TITRE	FAUTEUIL F1 - STRUCTURE D'ASSISE - ACT2	FAV-QUA-006-V001	Date : 29/05/2024
REDACTEUR	CECCHINI Arnaud

Date	29/05/2024	Coordonnées	assistance@capronpodologie.com
Product	Chairs F1 2000, F1 2000 Ergo, F1 Neo, F1 Neo Ergo, F1 3000, F1 3000 Ergo		
Lot(s)	All serial numbers are involved		
Destinataire	To the attention to all distributors of F1 chairs

Description of the problem giving rise to the safety information and potential risk

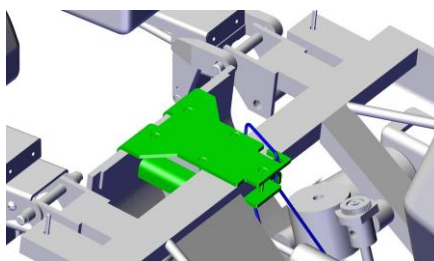
In collaboration with the company FIMET OY, manufacturer of the F1 armchair base, it has been detected that a weld in the structure of the seat frame could present a possible failure and cause the backrest to tilt backwards with a risk of fall of the patient.

Simple installation of a kit on the seat frame to secure the chair structure in case of failure. This kit consist of 2 parts, 5 assembly screws, a hex key. This kit has been designed so that the pratician can set it up himself with or without technical assistance from Capron Podologie using the assembly instructions manual provided.
